ADDENDUM #1
June 23, 2022

TO: ALL Prospective Bidders
PROJECT: N 33rd Street Transmission Main
BID REFERENCE #: 91244-020.0
BID OPENING DATE/TIME: **June 30, 2022 @ 3:30 p.m. Local Time**

N 33rd Street Transmission Main

Attachment B ***Response to Questions***

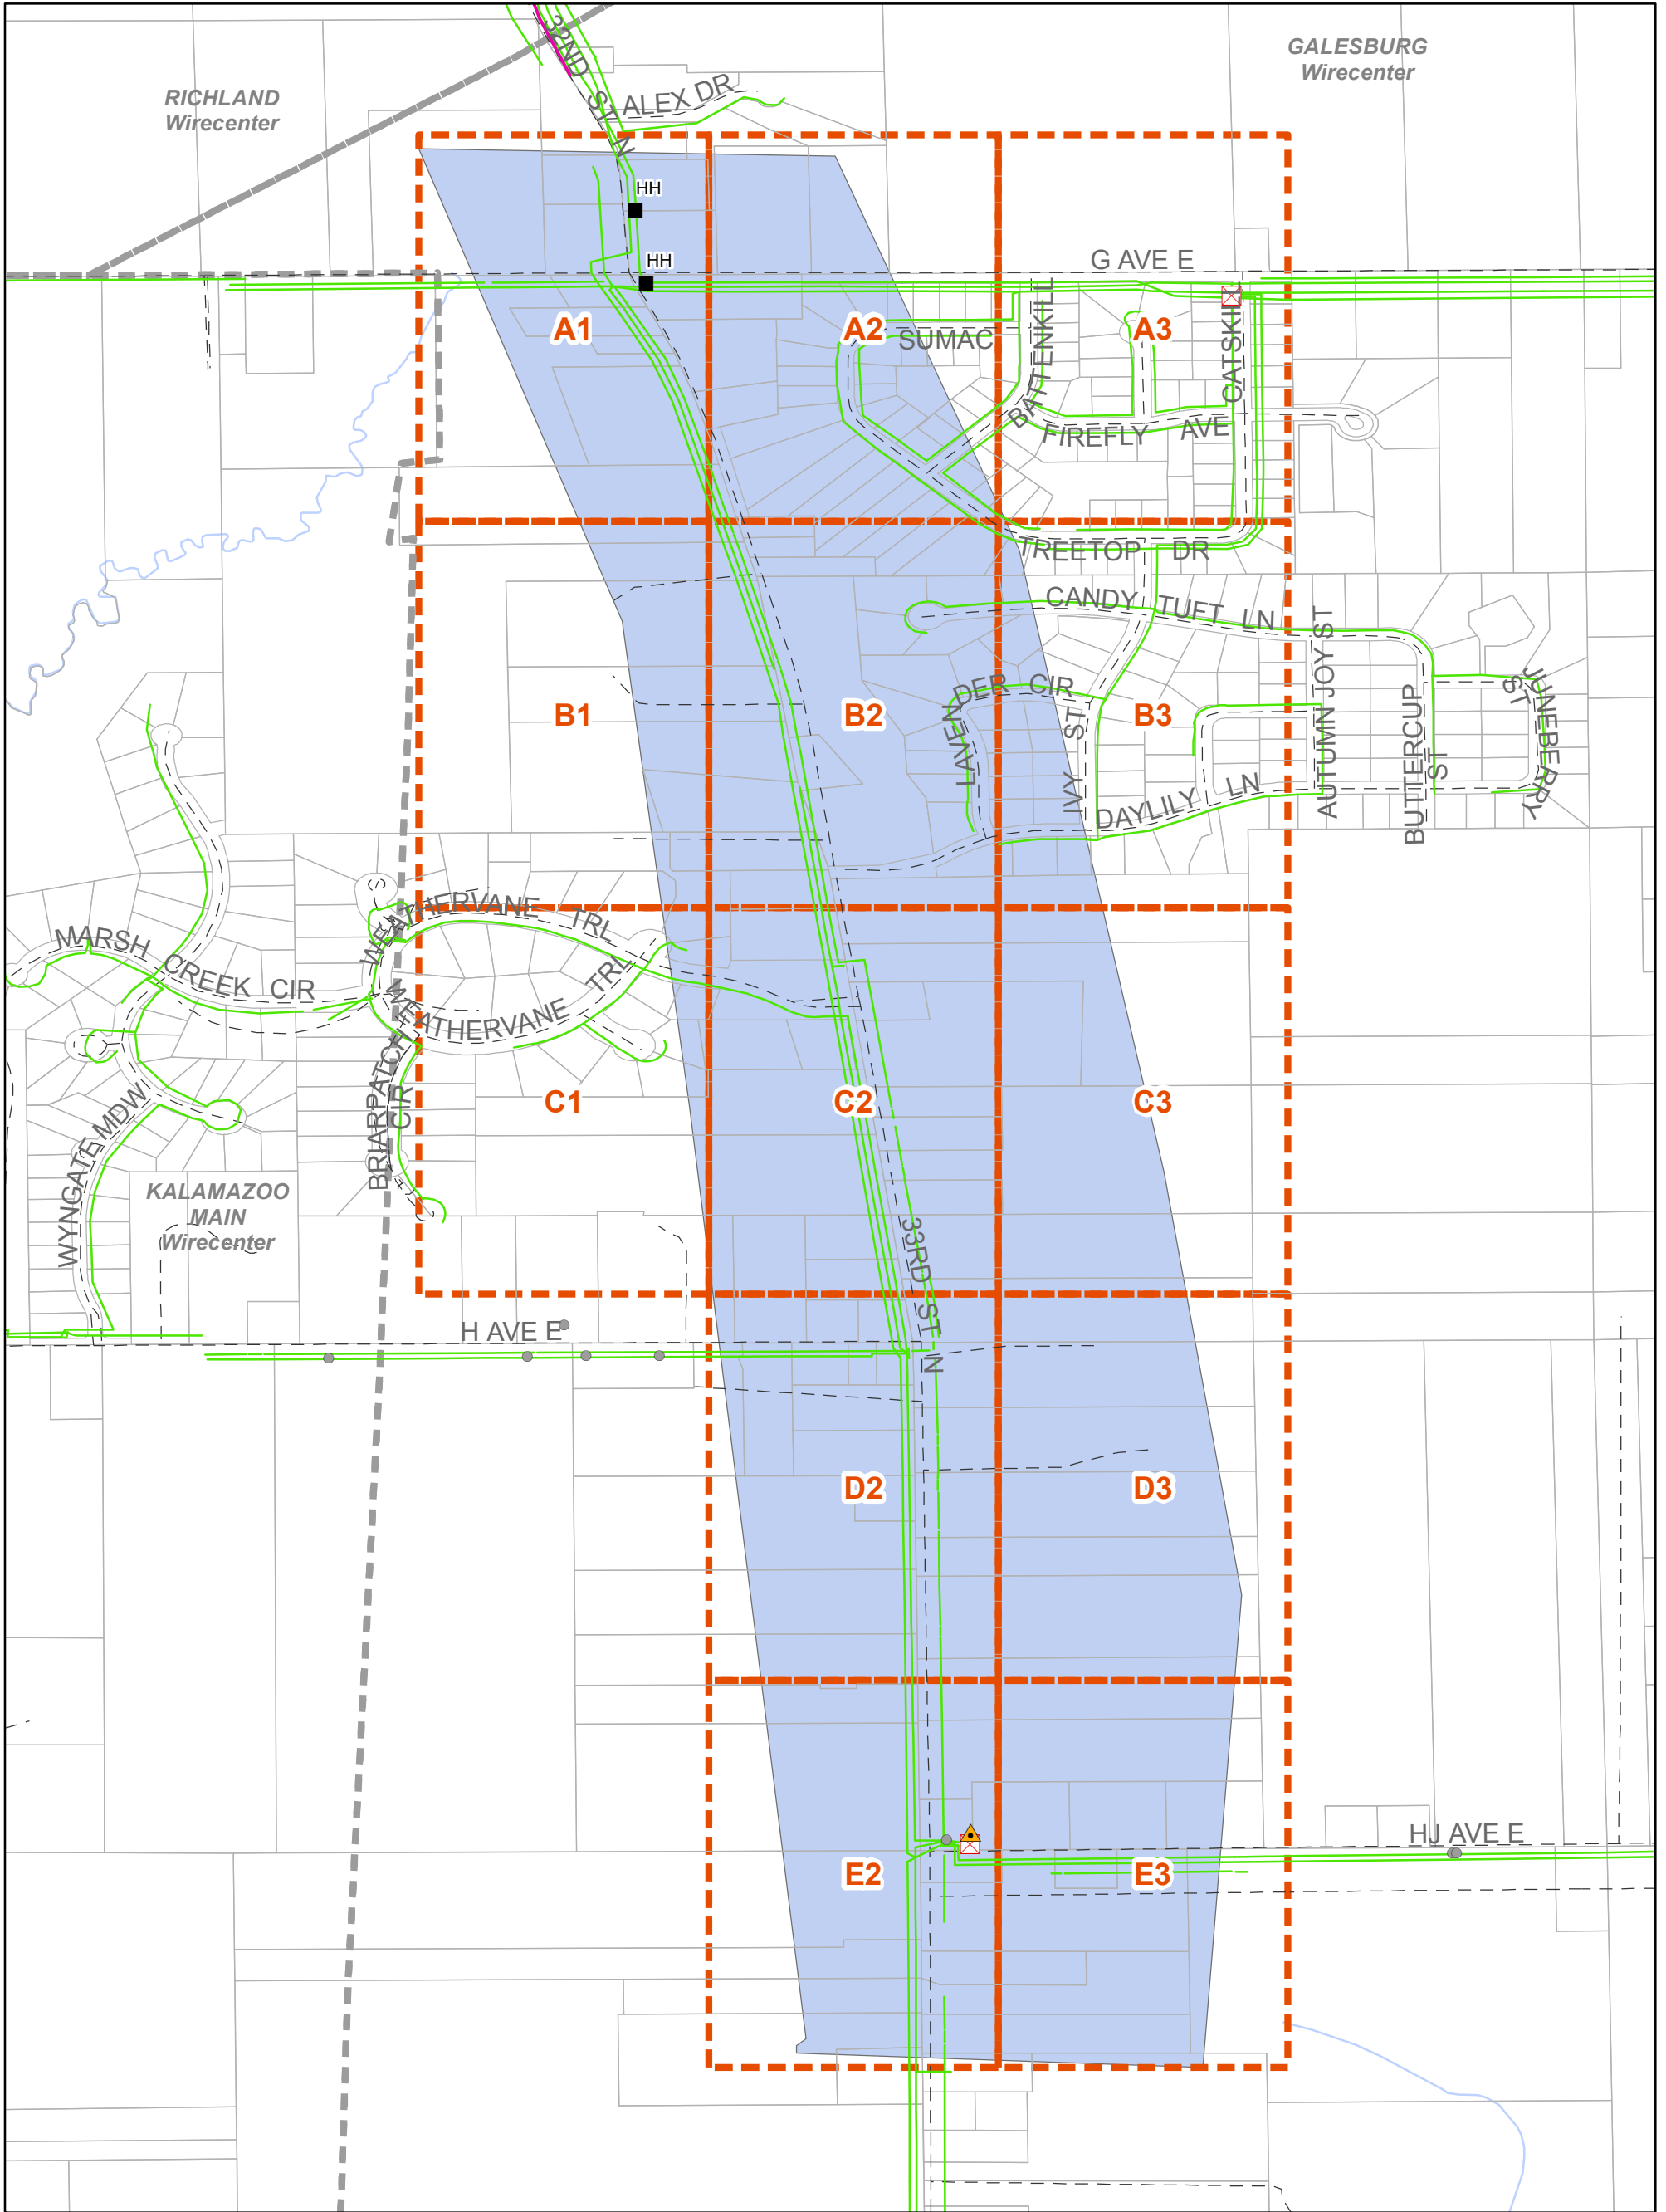
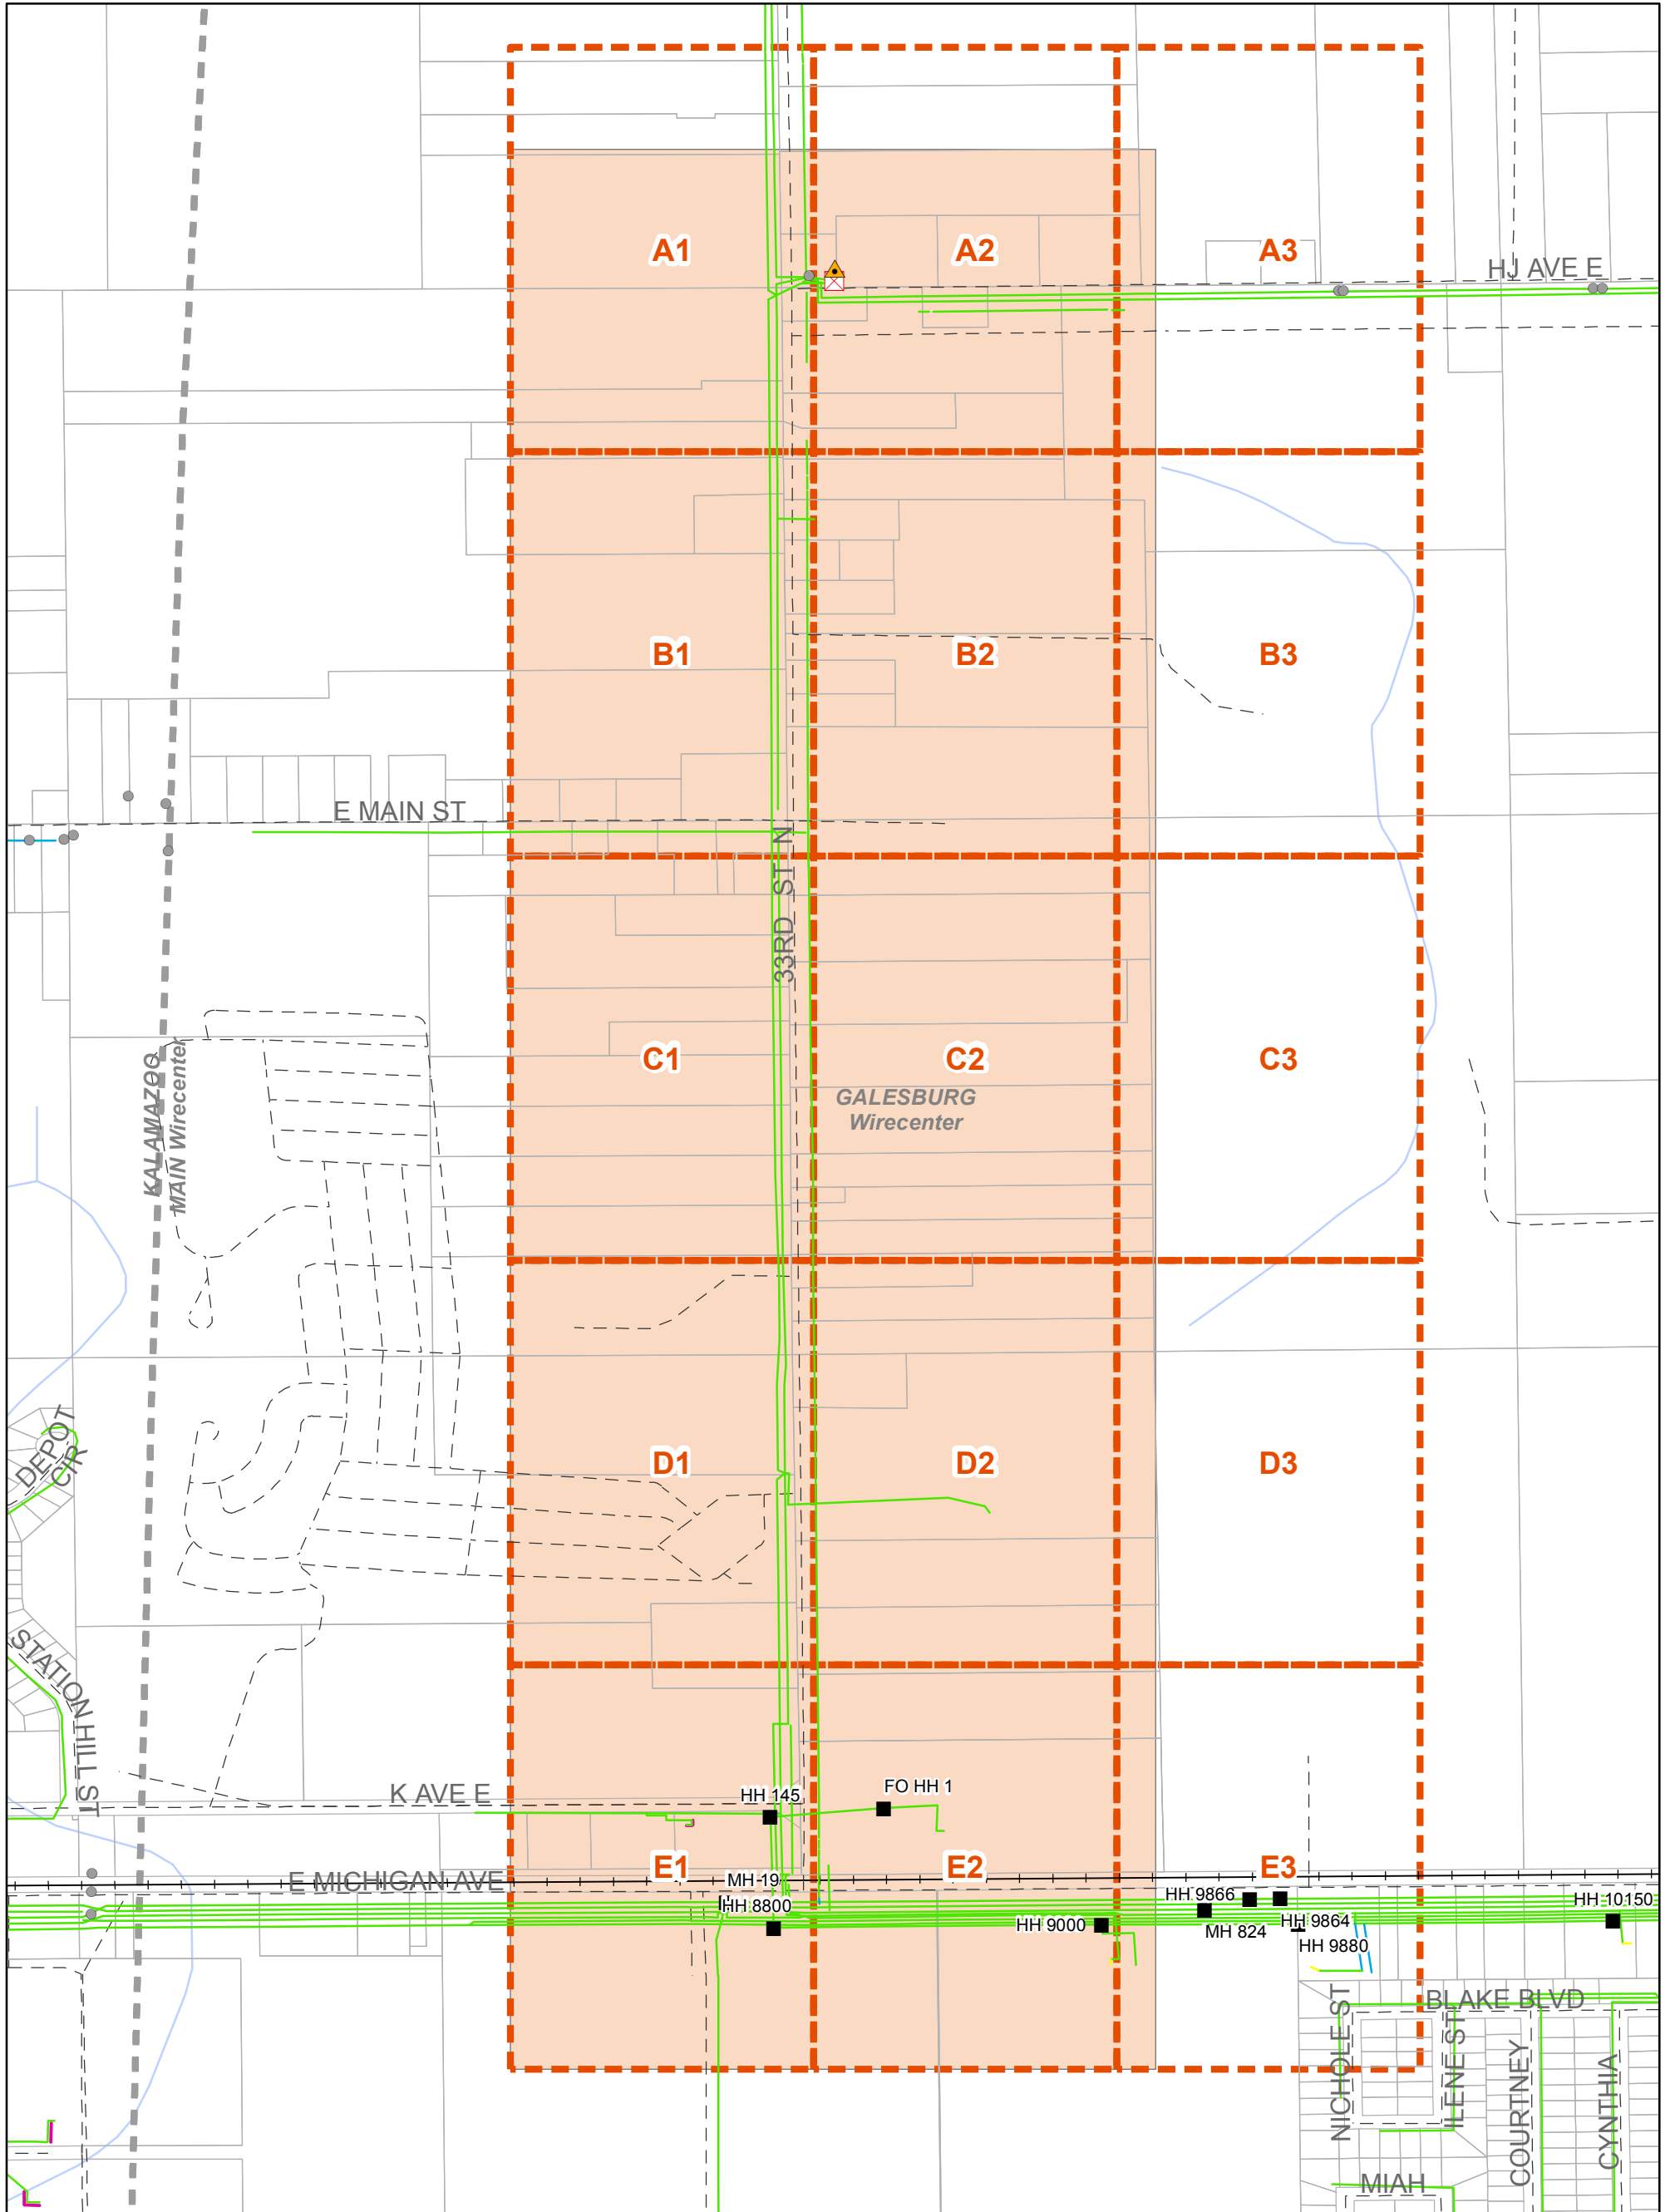
Q7: The plans show telephone pedestals throughout the project but, we are unable to locate the underground lines on the plans. The location of these lines could greatly influence construction/constructability. Please provide this information.

A: See attached MISS DIG AT&T and Charter maps obtained through a MISS DIG design ticket. The Contractor remains responsible for locating existing utilities and providing temporary support of existing utilities as required during construction.
